December 9, 2016

Subject: Response to Comments
Sediment Investigation Results and Proposed Additional Sediment Sampling
Sims Group USA Corporation, Redwood City, California

On behalf of Sims Group USA Corporation (Sims), Terraphase Engineering Inc. (Terraphase) submitted the *Interim Sediment Investigation Results and Proposed Additional Sediment Sampling* report (dated August 31, 2016) to the United States Environmental Protection Agency (EPA). On October 26, 2016, the EPA provided comments on the report. This letter responds to EPA's comments.

CLIENT: Sims Metal Management	**Proposed Additional Surface and Coring Sediment Locations - Wharf 3**
PROJECT: Sediment Investigation Report	
PROJECT NUMBER: 0012.001.007	**FIGURE 17**

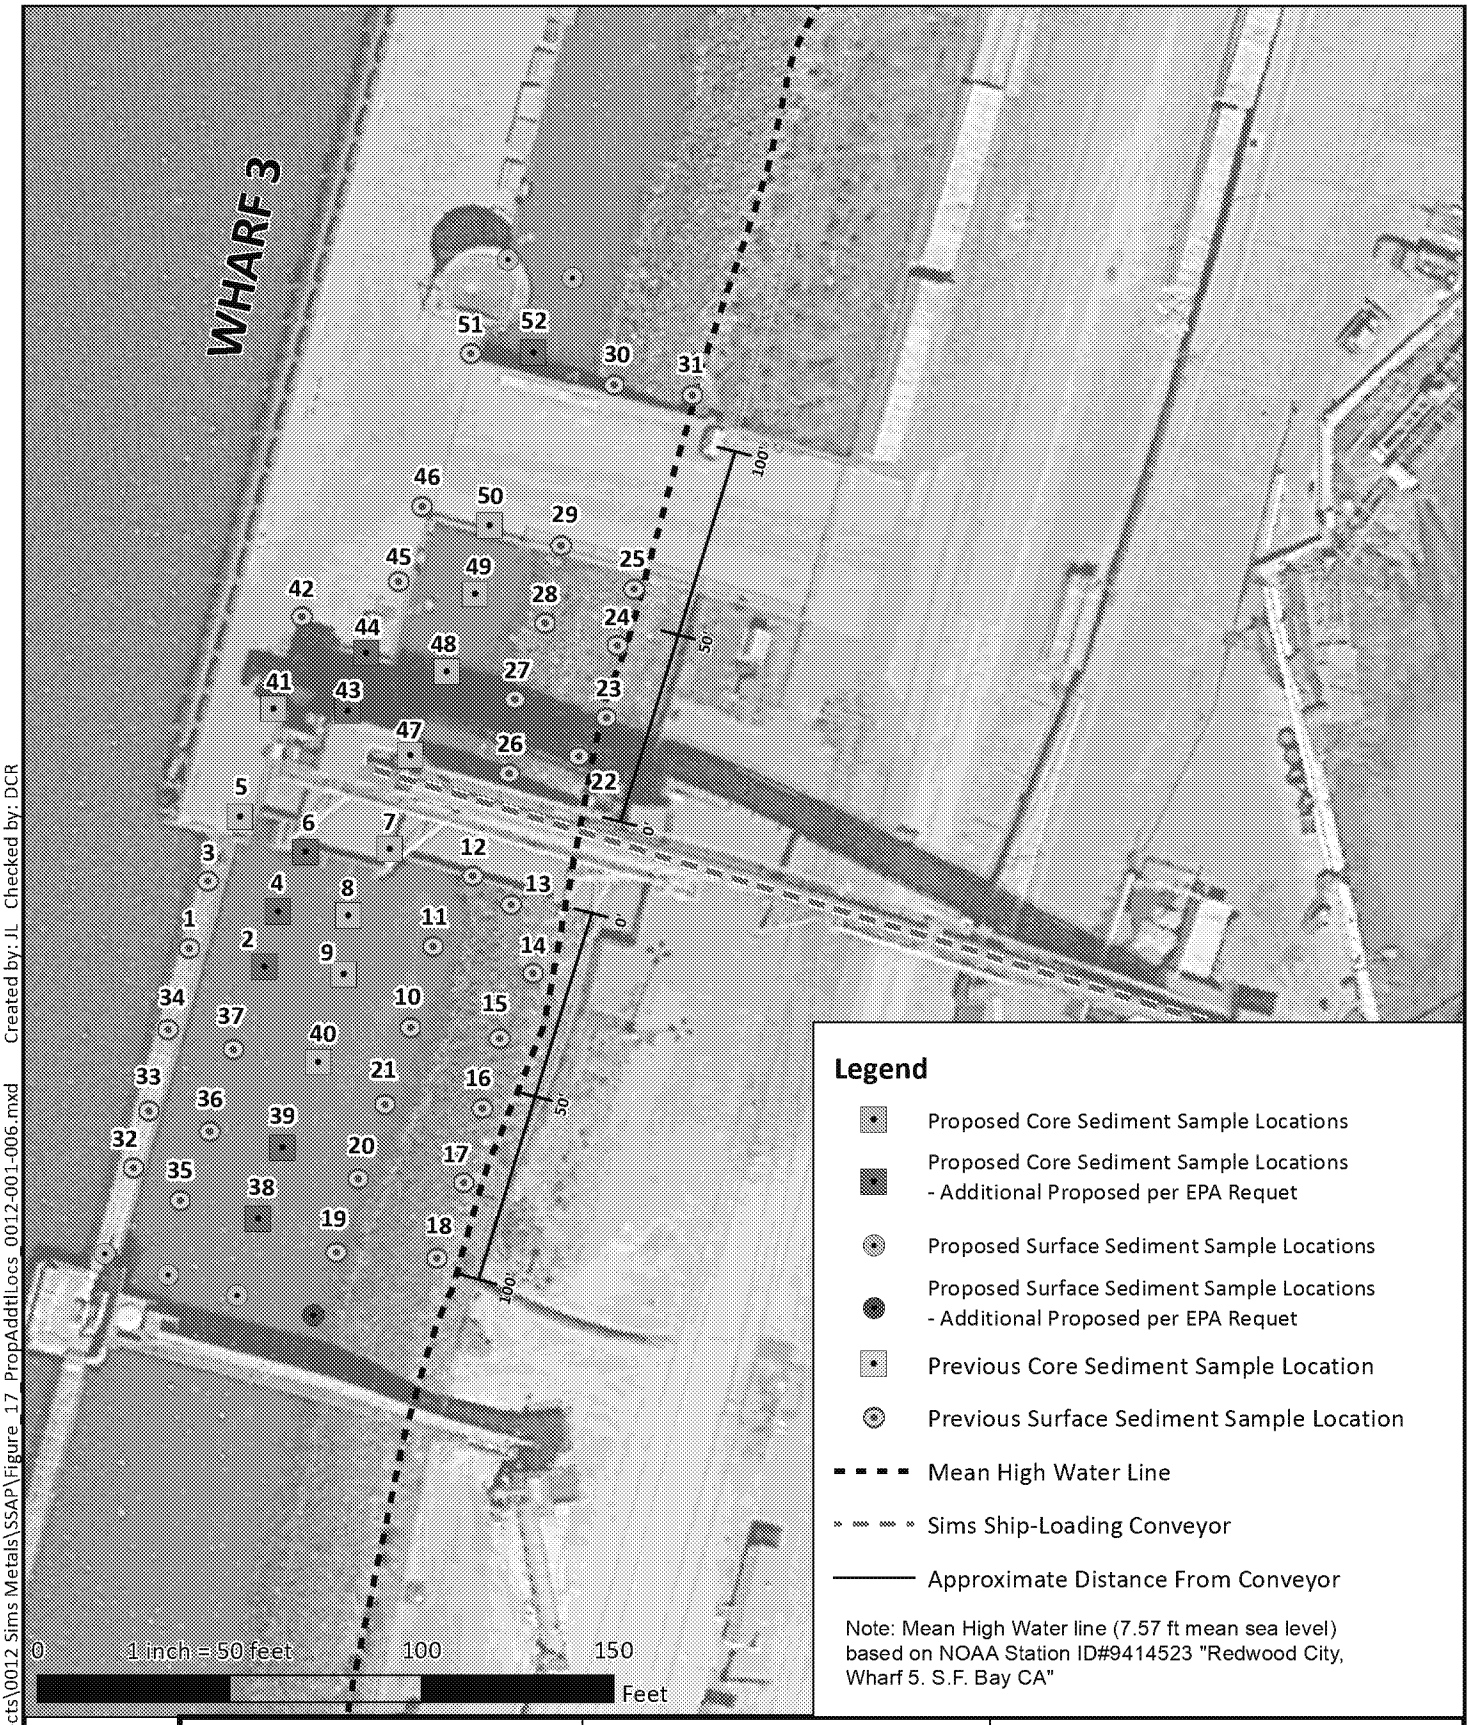
<u>EPA Comment</u>
PROJECT AREA SAMPLING
Add 8 Core Locations for lateral distribution*: The transect core locations proposed by Sims to the south of Wharf 3 (locations 7, 8, 9, 40) should also include core samples at locations 39 and 38. In addition, the transect core locations proposed by Sims to the north of Wharf 3 (locations 47, 48, 49, 50) should also include location 52. Lastly, in addition to the core samples for locations 5 and 41 proposed by Sims, EPA believes core samples should also be taken at locations 6, 4, 2, 43 and 44.*

EPA Comment
Surface Samples*: Sims has proposed taking 5 more surface samples within the project area (3 locations approximately 25 feet south of locations 32, 35, and 38, and 2 locations north of locations 51 and 52). We agree with those 5 locations, but believe that Sims should also take at least one other surface sample south of location 19.*

Response
The additional core sampling locations requested by the EPA will be added to the scope of work. A total of 18 sediment cores will be collected. The core sample identification numbers are summarized in Table 1. Figure 17 has been revised to indicate planned core sediment sample locations.

Response
Figure 17 has been revised to indicate that a surface sediment sample will be collected at location 19 in addition to the previously proposed locations. A total of six surface ponar grab samples will be collected.

CLIENT: Sims Metal Management	**Proposed Additional Background Riprap Sediment Sample Locations - Wharf 2**
PROJECT: Sediment Investigation Report	
PROJECT NUMBER: 0012.001.007	**FIGURE 18a**

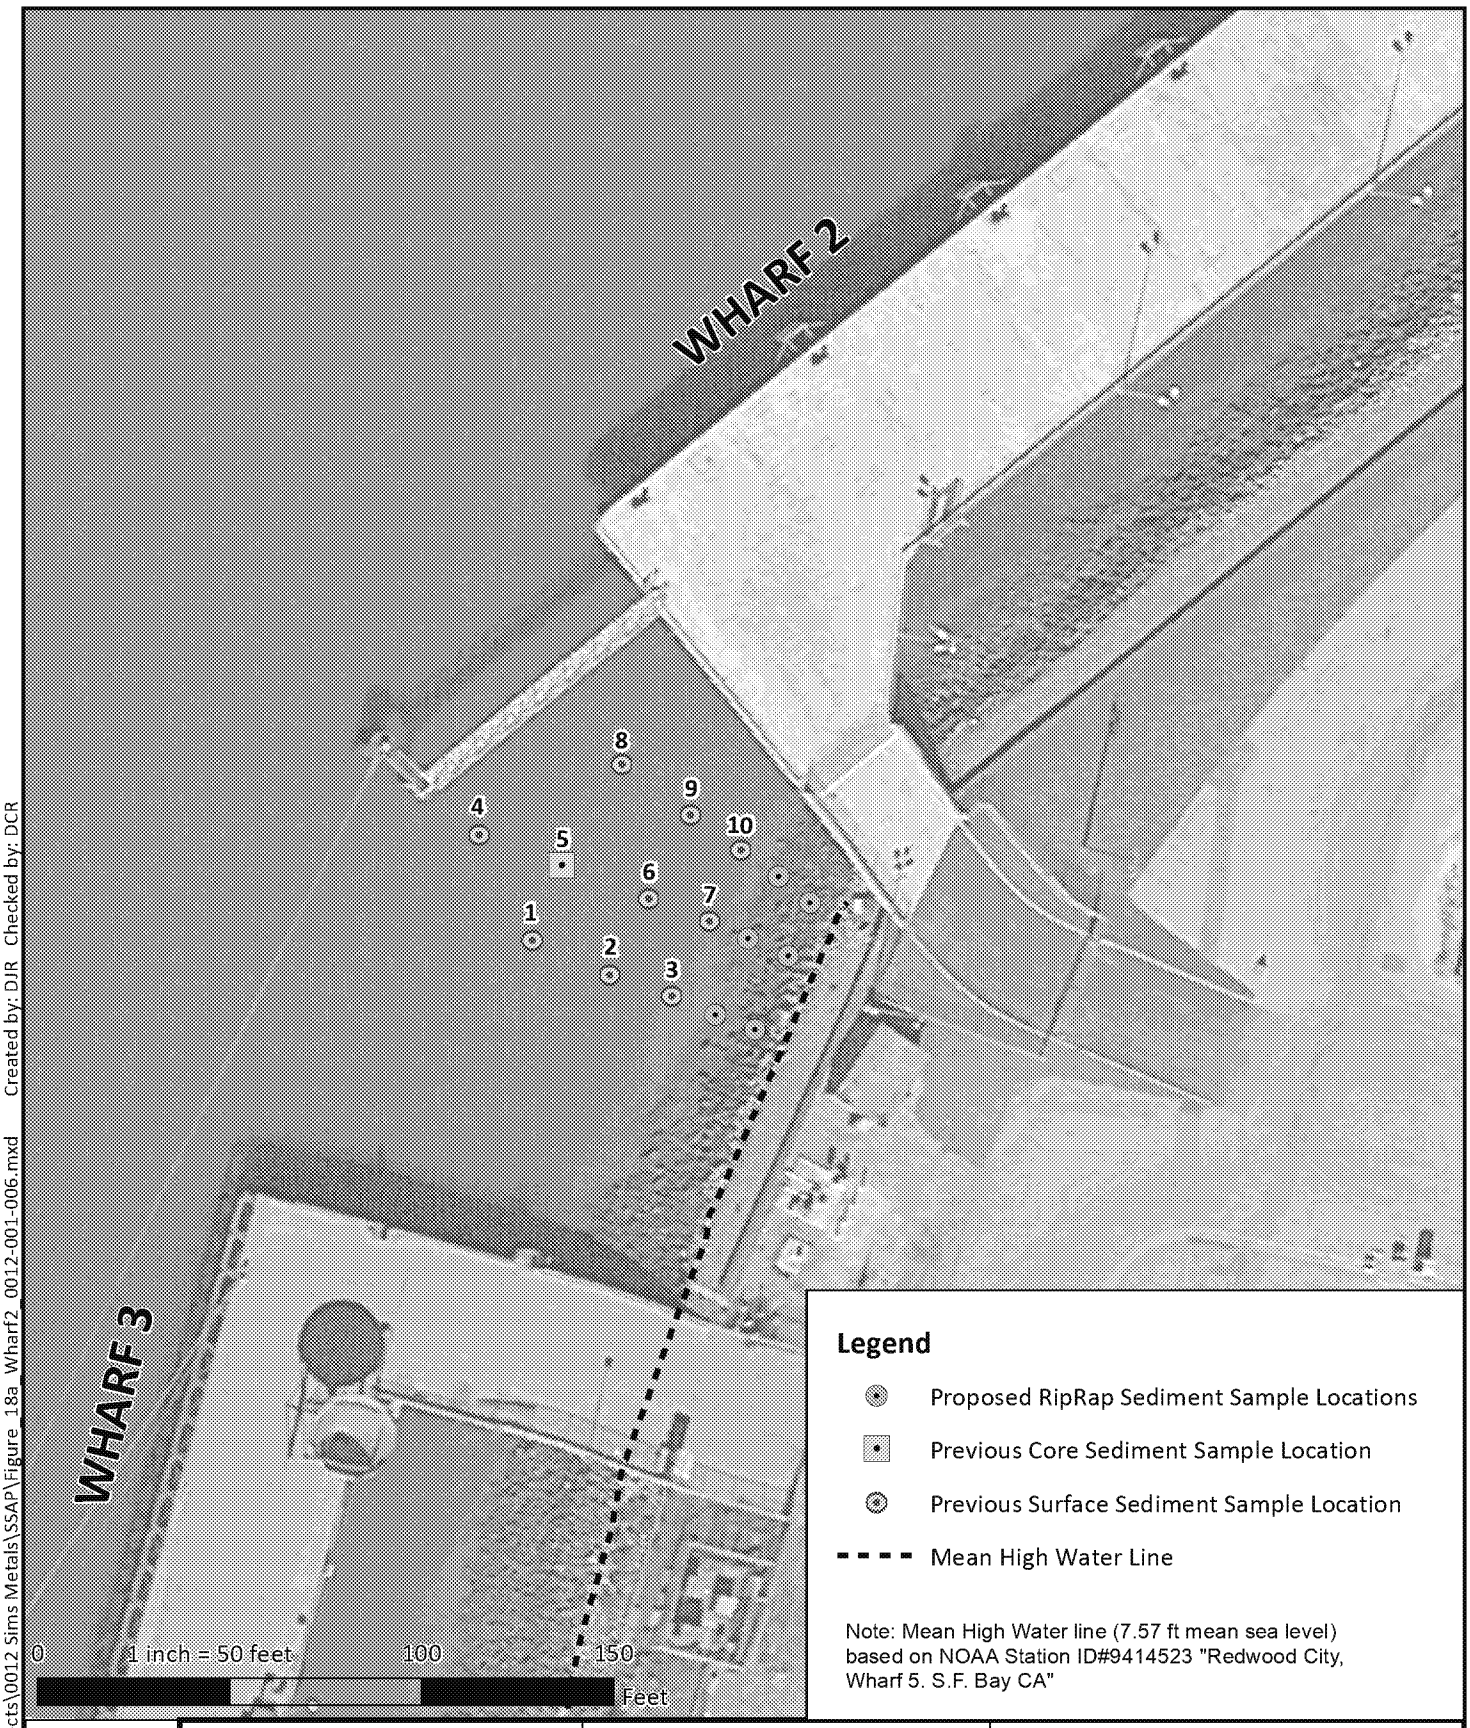
EPA Comment
BACKGROUND AREA SAMPLING
Surface Samples*: Sims has proposed taking 6 additional surface samples at each of the 3 background areas (Figures 18a, b, and c). In general, we agree with taking those samples, but for comparison, we believe they should be at elevations that are in line with the riprap surface sediments that were taken in the project area. Based on the aerial photos provided in its report, the locations Sims has proposed in the background areas seem closer to the mean high water line than the surface riprap samples within the project area. Please add a mean high water line to Figures 18a, 18b, and 18c and evaluate if the background sample locations need to be adjusted to match the elevation of similar grab samples in the project area.*

The surveyed MHW line has been added to all figures that depict the background sample locations from the prior phase of investigation, and the proposed additional locations (Figures 18a, 18b and 18c). The proposed background locations are all below the MHW line.
